34703A-7 SERVICE NOTE

-hp- MODEL 34703A DCV/DCA/OHMMETER

TEMPERATURE SENSITIVE OHMS OPERATION

Figure 3.

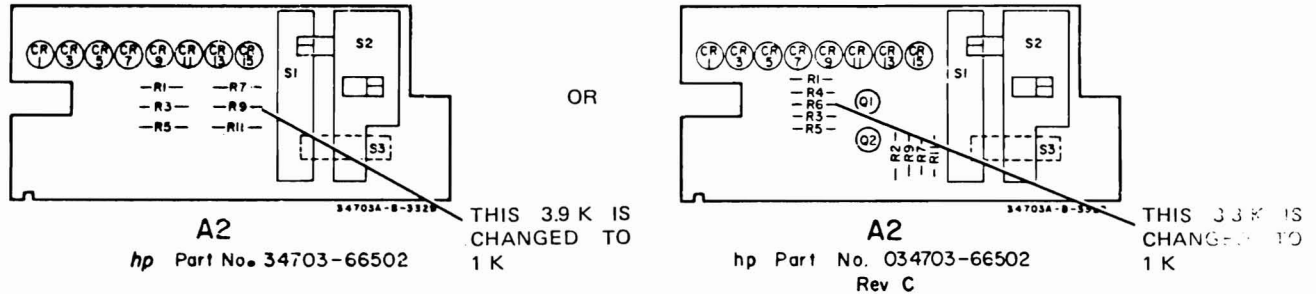
A limited number of the early factory modified 34703A's may exhibit erratic OHMS, especially at elevated temperatures. The logic signal HPFA may not come up high enough to be recognized as a logic high. When this happens, the outputs of the Analog Switch Controller A1U19 (-hp- Part Number 1818-2133) become erratic causing unpredictable OHM operation.

The problem is eliminated by changing the value of a resistor on the A2 Front Panel Board. Instruments modified in accordance with Service Note 34703A-6 already incorporate this change. Instruments factory modified and shipped after February 14, 1975 will also incorporate this change.

4. Refer to the following component locator to determine if the A2 board is Revision C or earlier.

If the A2 board is Revision C, change the 3.3 k Ω resistor A2R6 (-hp- Part Number 0683-3325) to a 1 k Ω resistor (-hp- Part Number 0683-1025). If the A2 board is prior to Revision C, change the 3.9 k Ω resistor A2R9 (-hp- Part Number 0684-3921) to a 1 k Ω resistor (-hp- Part Number 0683-1025).
